STAFF RECOMMENDATION

1411 Boscobel Street

November 16, 2016

Description of Project: Application is to revise a previously-approved design for duplex infill on the lot.

Figure 2. Front façade of the previously-approved infill and the revised plan.

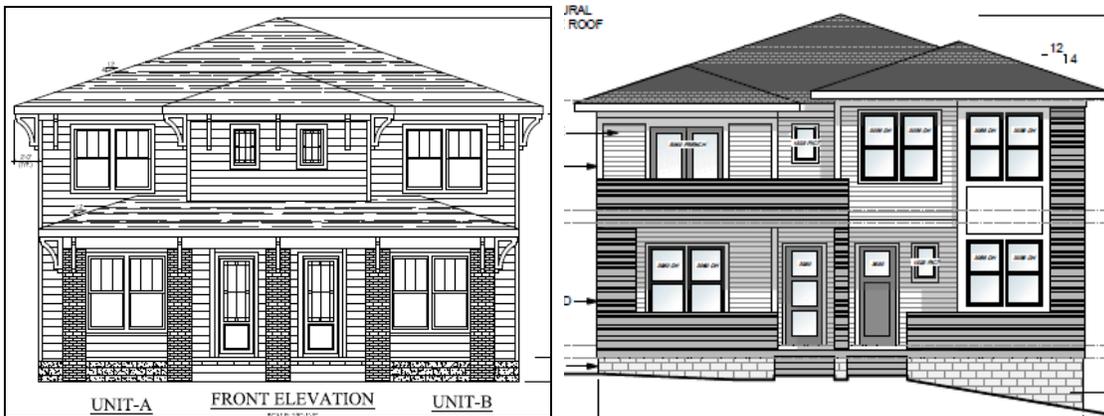
The design of the front of the house has varying planes, particularly on the second level. Staff recommends simplifying these planes in order to keep the overall form of the house in line with what is typically approved in Lockeland Springs for infill. Staff finds that the infill's height and scale to meet Sections II.B.1.a. and b. of the design guidelines.

*The applicant has proposed two different front door designs for the two different units. Staff recommends that the doors be identical in order to maintain a cohesive look to the infill. In the past, the Commission has required duplexes to look like one building, as they did historically. Changes in window and door design or vertical changes in material accentuate that the building is two units and have not been approved in the past.

The plans show a wall dividing the porch to separate the two units, and staff recommends that the wall be removed in the area of the porch (although it may remain in the recessed area). In the past, the Commission has not allowed a wall dividing a porch as it accentuates the fact that the building is two units. A front walkway will be added from

1. The finished floor height be consistent with the finished floor heights of the adjacent historic houses, to be verified by MHZC staff in the field;
2. The various planes on the front façade be simplified; Staff approve the final details, dimensions and materials of windows and doors prior to purchase and installation, and the two front entry doors be identical;
3. Staff approve the roof color;
4. The front porch wall be removed;
5. All double and triple window openings shall have a four to six inch (4" – 6") mullion in between them;
6. The existing front gravel driveway be removed; and
7. The HVAC shall be located behind the house or on either side, beyond the midpoint of the house.

SITE PLAN
 HPR LOT 172 BLK Q
 LINDSLEY HOME
 1411 BOSCOBEL ST
 NASHVILLE, TN 37206
 PREPARED FOR: MIKE MATHEWS

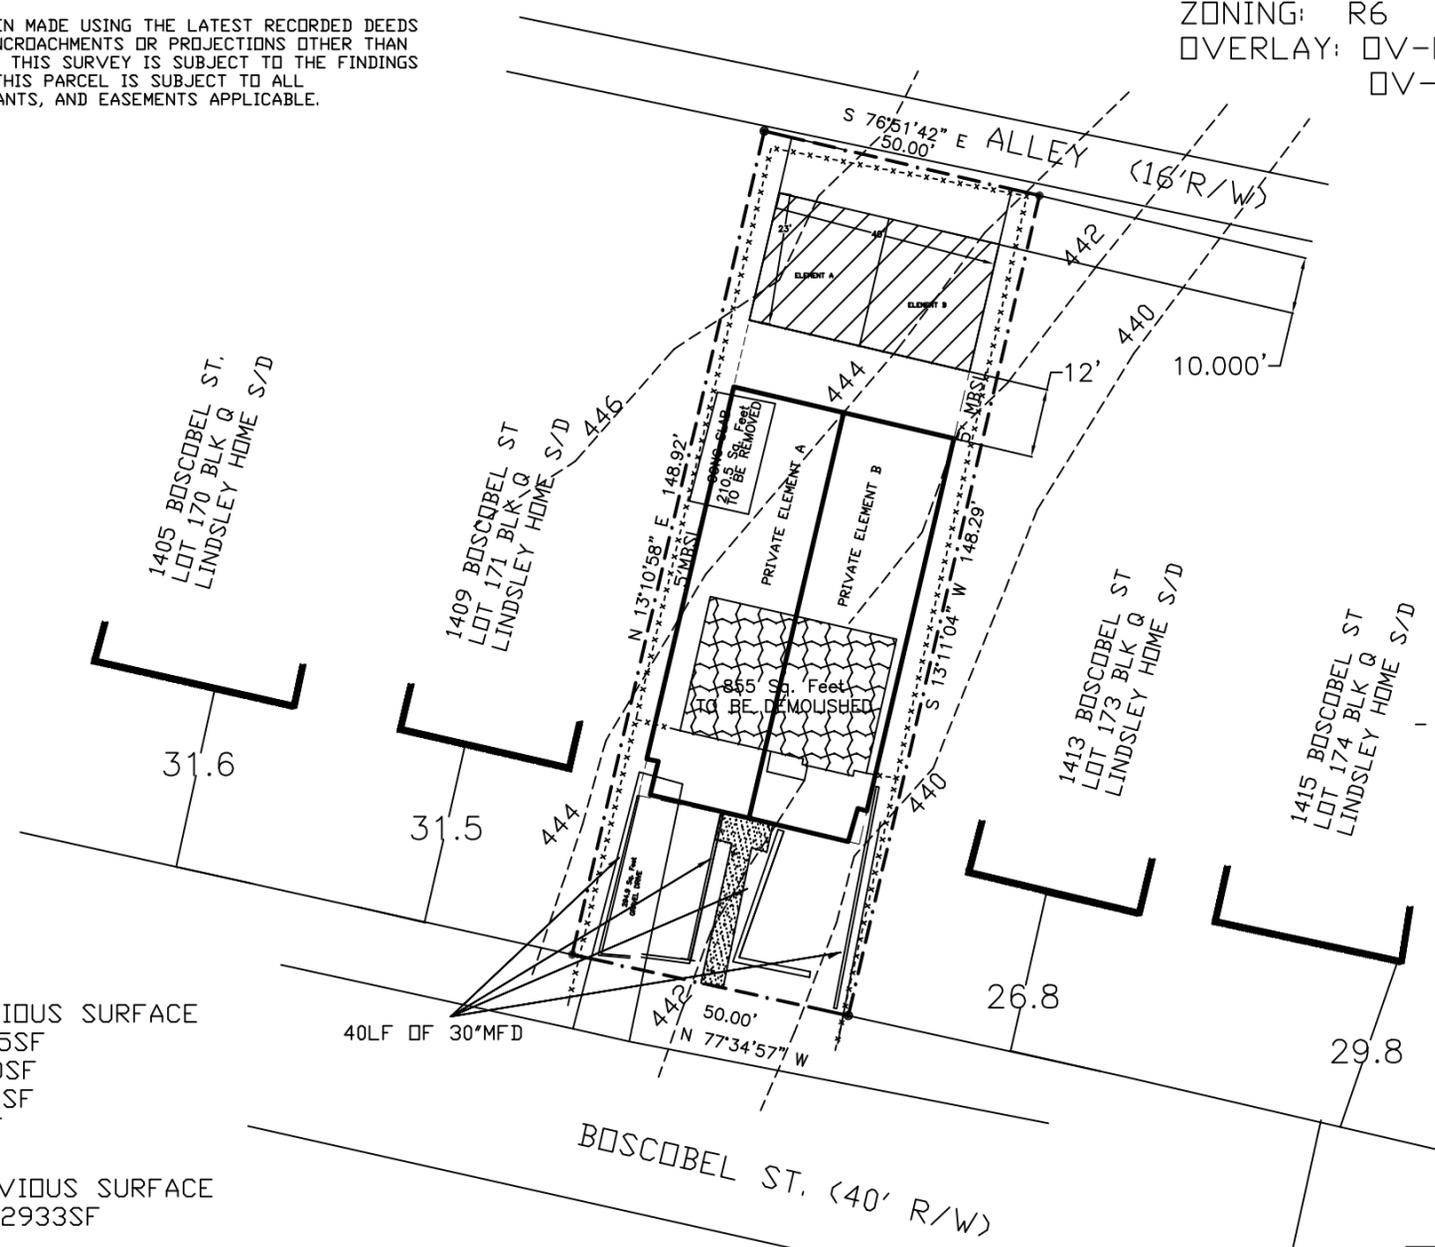
Appurtenances & Utilities: The location of the HVAC and other utilities was also not noted. Staff asks that the HVAC be located on the rear façade, or on a side façade beyond the midpoint of the house. The front yard will include modified French drains. Staff recommends that the existing gravel driveway be removed, as front-yard parking is not a historic characteristic of the neighborhood.

FRONT ELEVATION
SCALE: 1/8"=1'

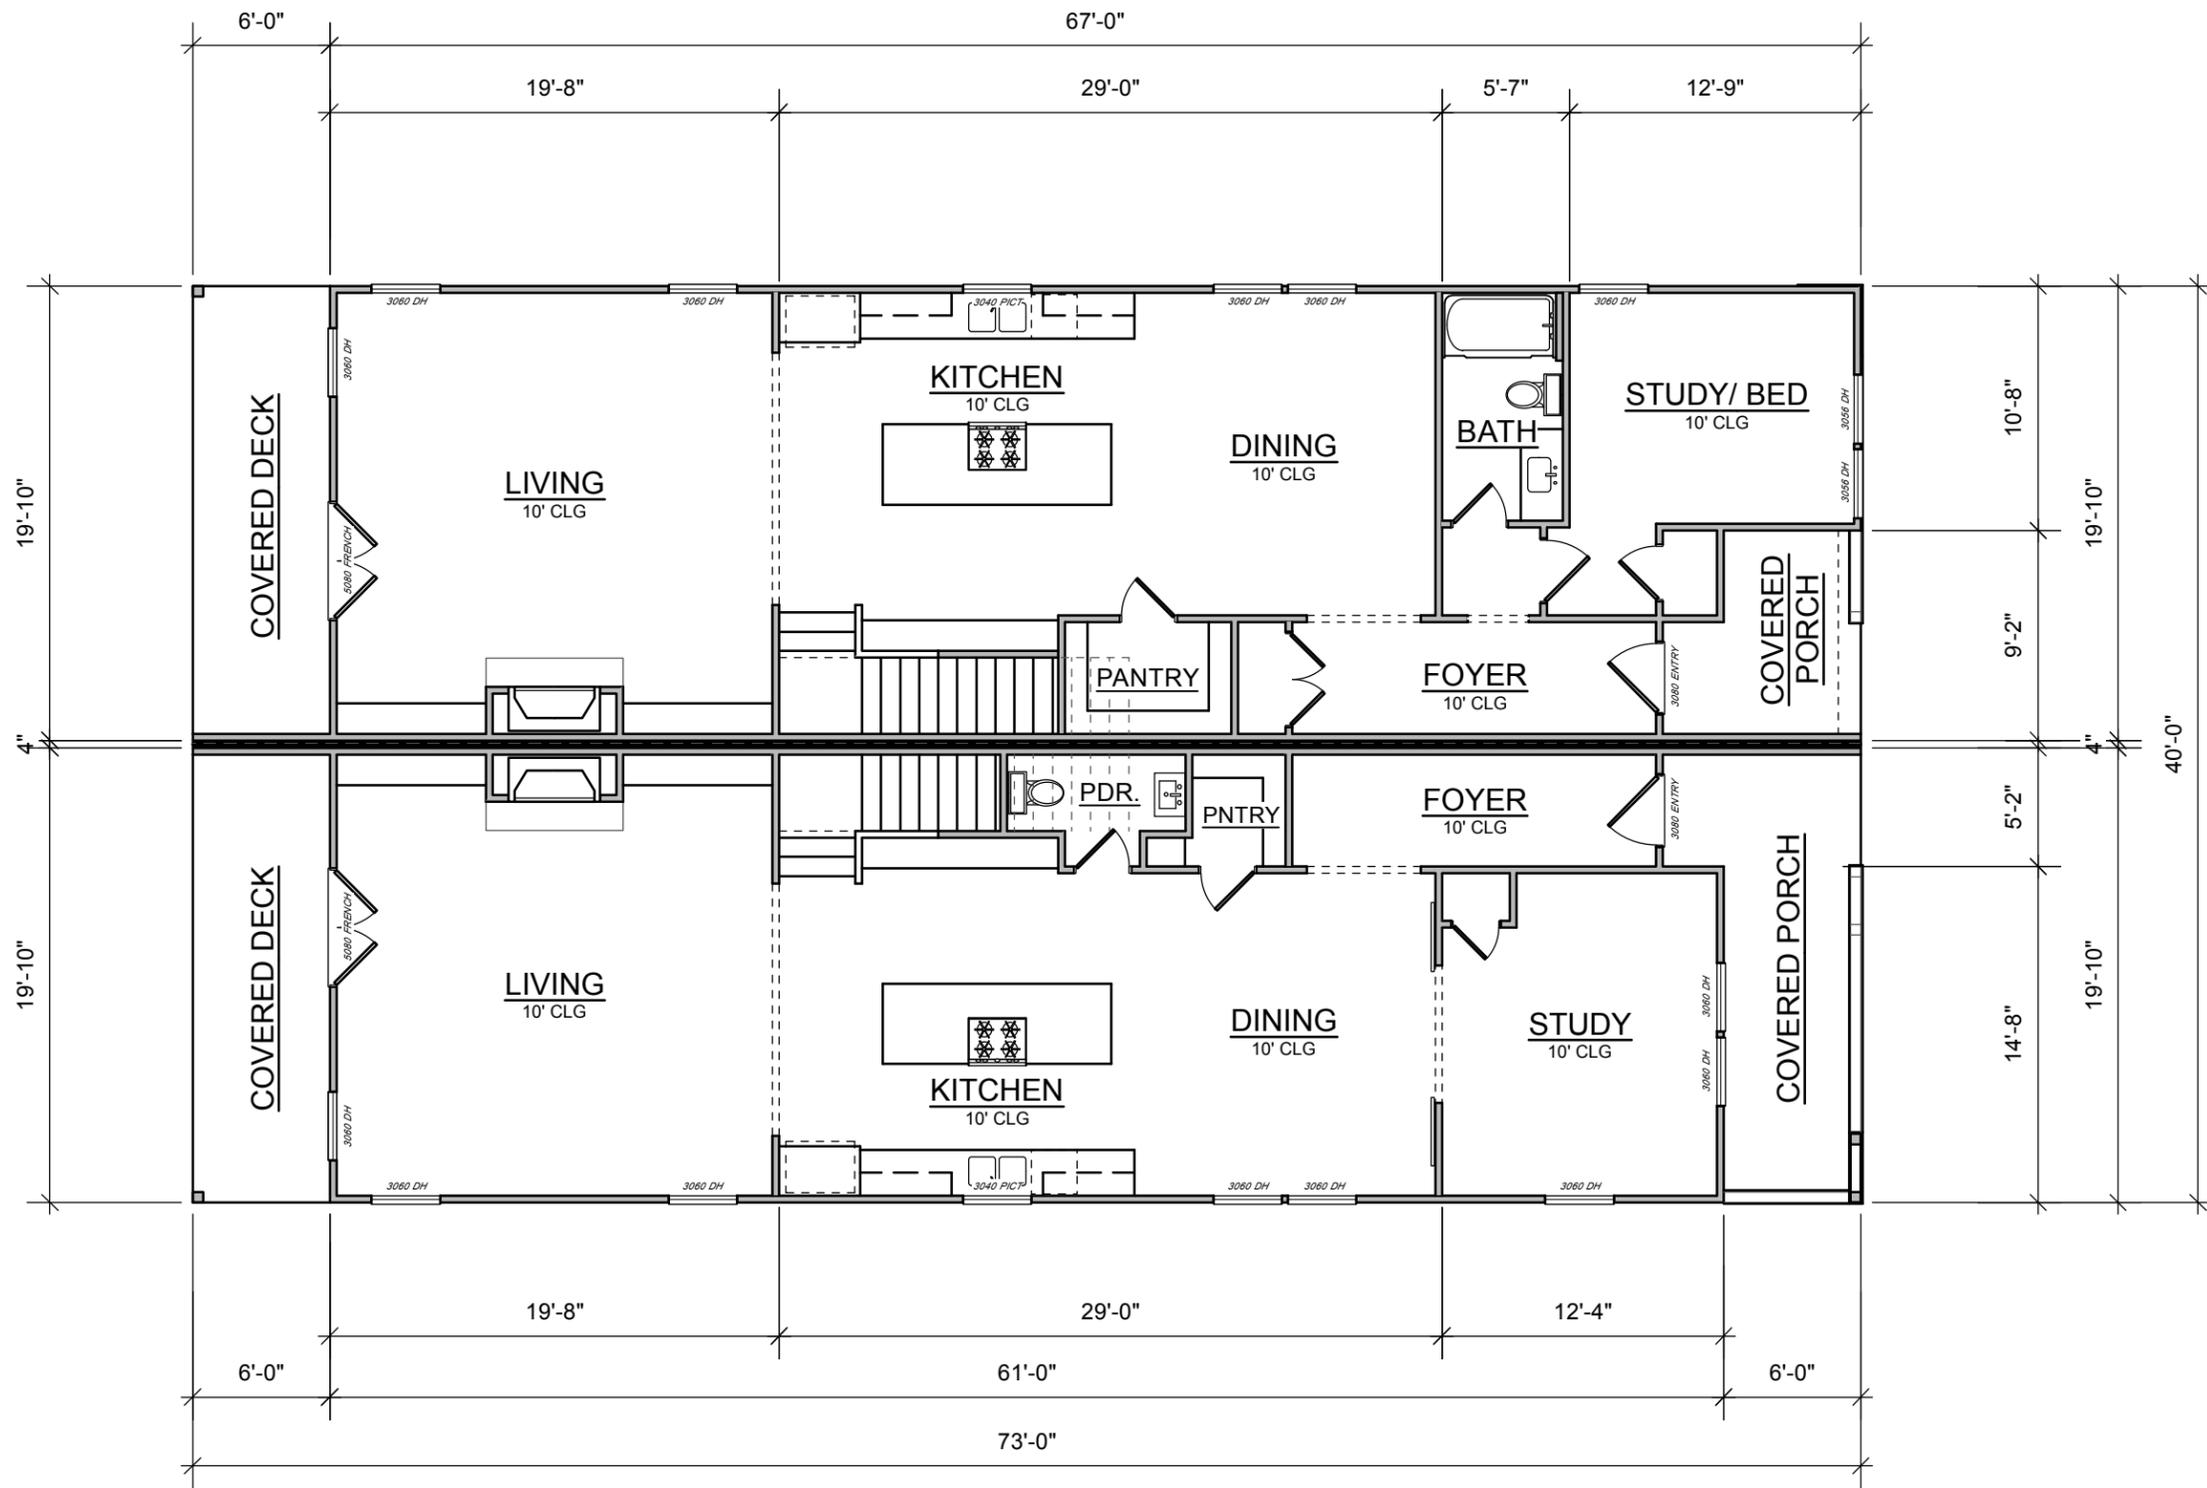
Roof form: The house’s primary roof form will be hipped with a 4/12 slope. The design guidelines state that roof pitches should generally be a minimum of 6/12. However, on this block of Boscobel Street, there is little historic context, and many new infill houses have flat roofs. Staff therefore finds that the low-pitched hipped roof is appropriate. The porches and the second story bay will also have hipped roof with 4/12 pitches. Staff finds that the proposed roof form meets Section II.B.1.e. of the design guidelines.

Proportion and Rhythm of Openings: The windows on the proposed infill are generally twice as tall as they are wide, thereby meeting the historic proportions of openings. The windows on the ground floor are taller than those on the second story. There are no large expanses of wall space without a window or door opening. Staff recommends that all double and triple window openings have a four to six inch (4" – 6") mullion in between them. Staff finds the project's proportion and rhythm of openings to meet Section II.B.1.g. of the design guidelines.

1ST FLOOR PLAN
 SCALE: 1/8"=1'

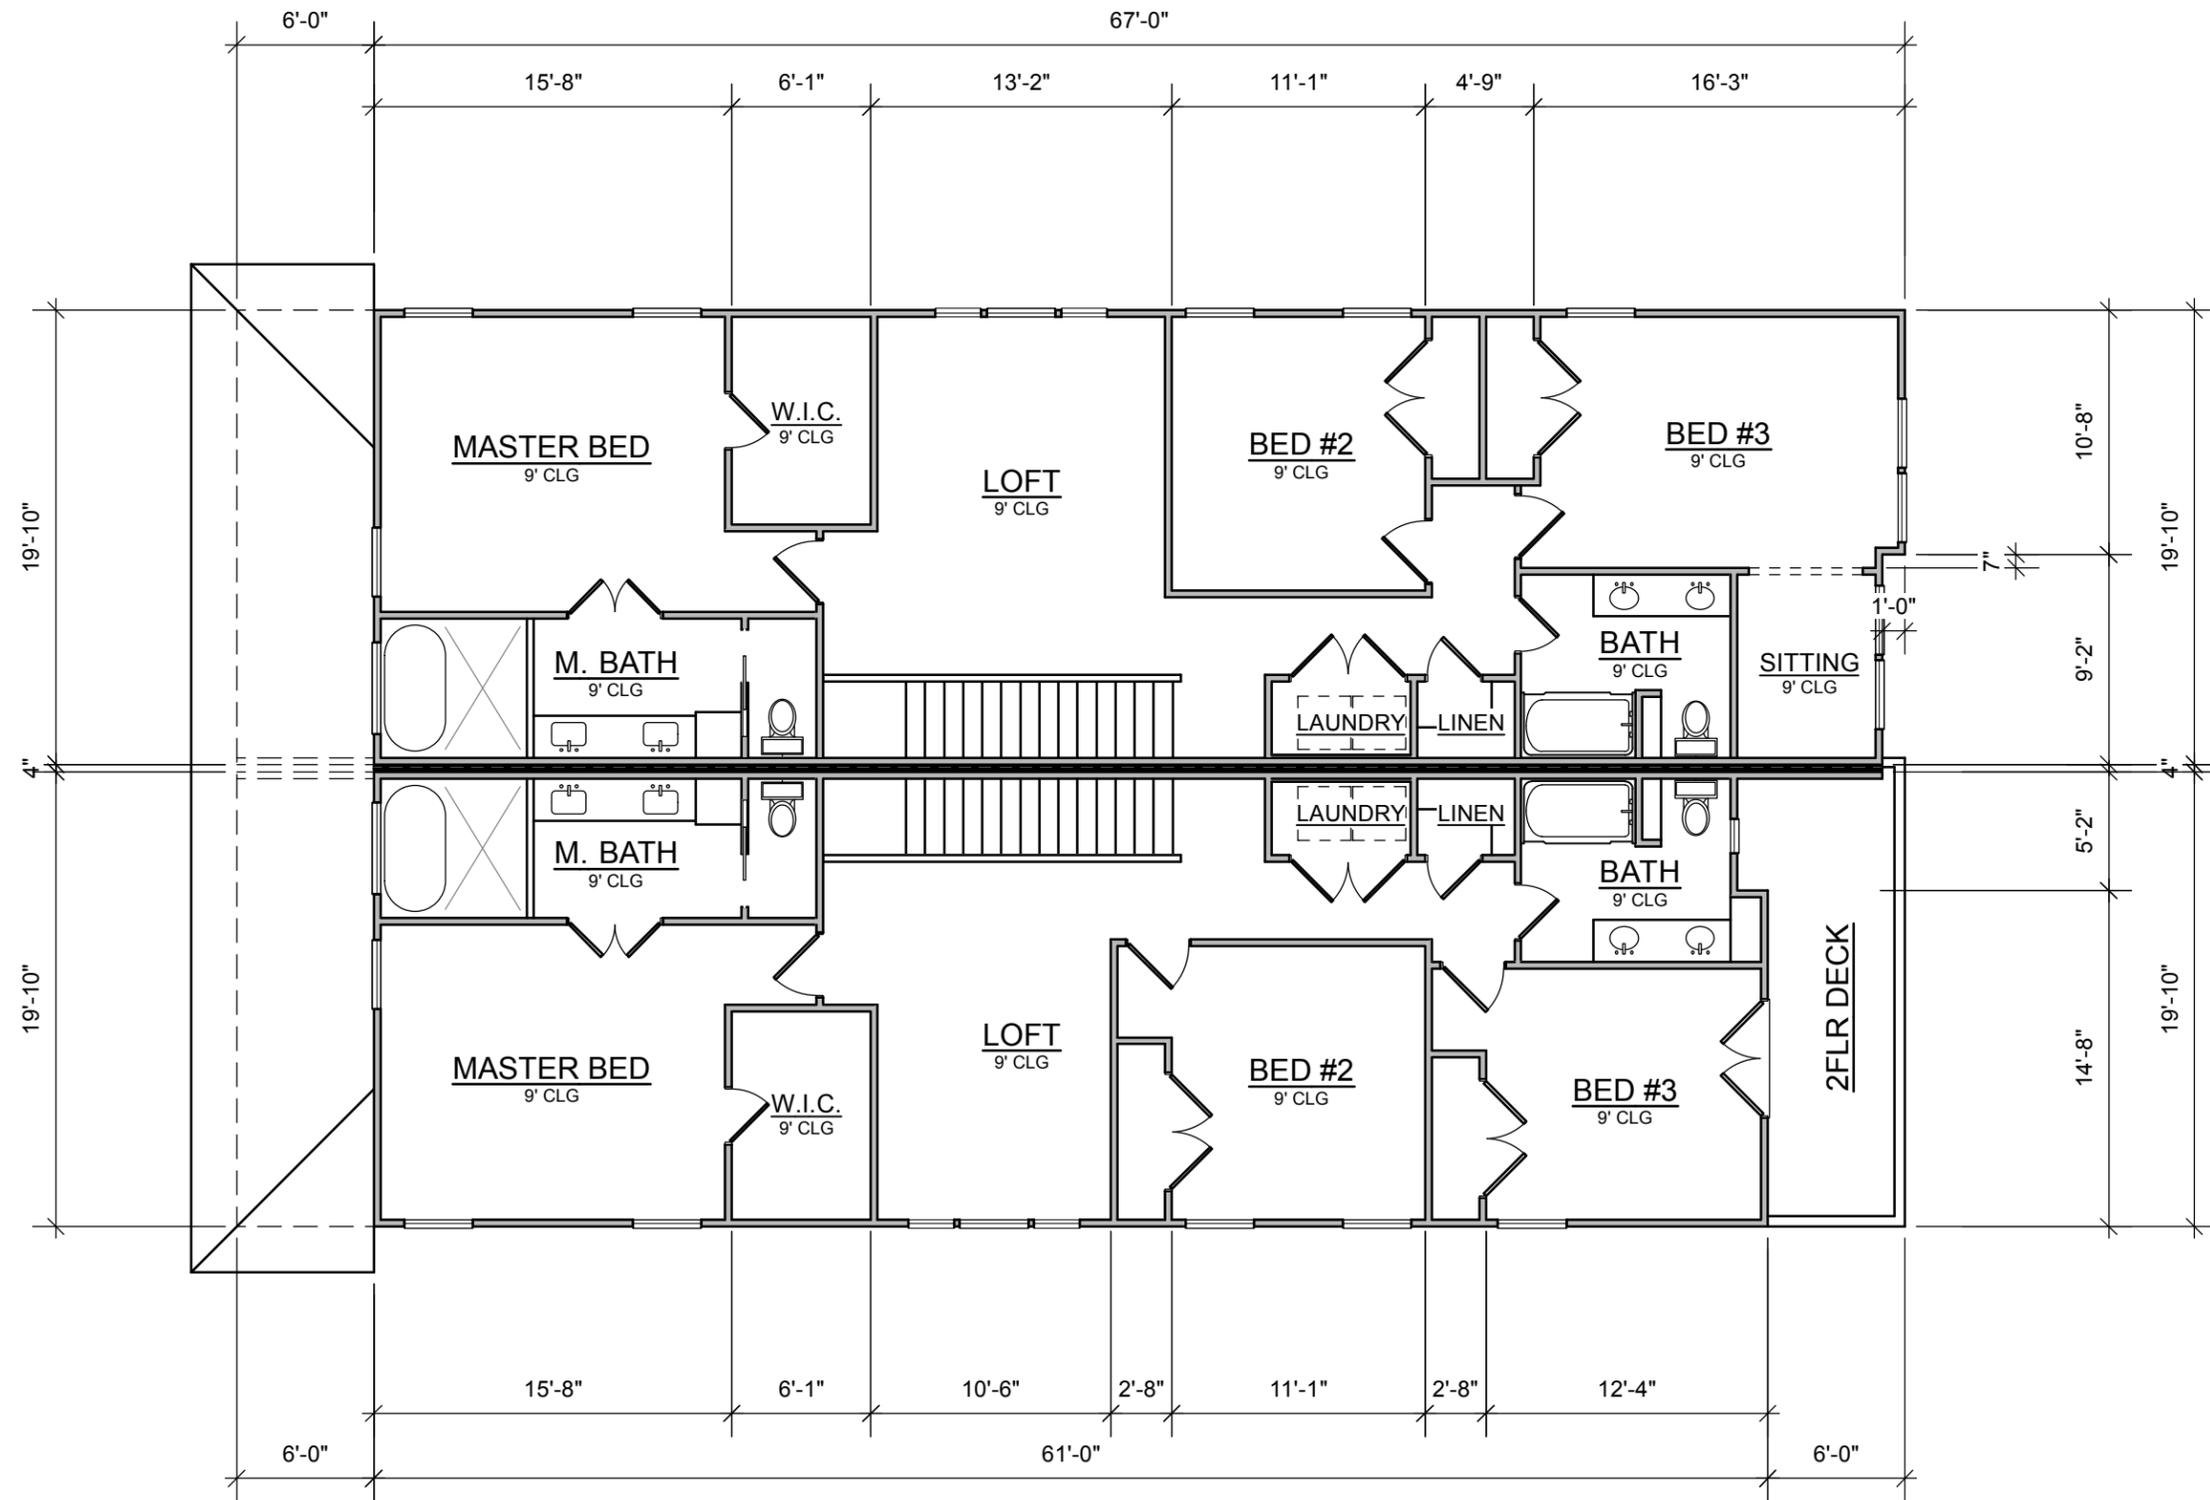
Orientation: The new infill will be a duplex, with two front entries facing Boscobel Street. The entries will be located behind a six foot (6’) deep front porch on the left and stoop on the right. The entrances will be recessed an additional three feet (3’) from the front wall of the house. The left unit includes a second story balcony over the porch roof. Such a balcony would not be appropriate on many streets on Lockeland Springs but is appropriate on this block of Boscobel where there is little historic context.
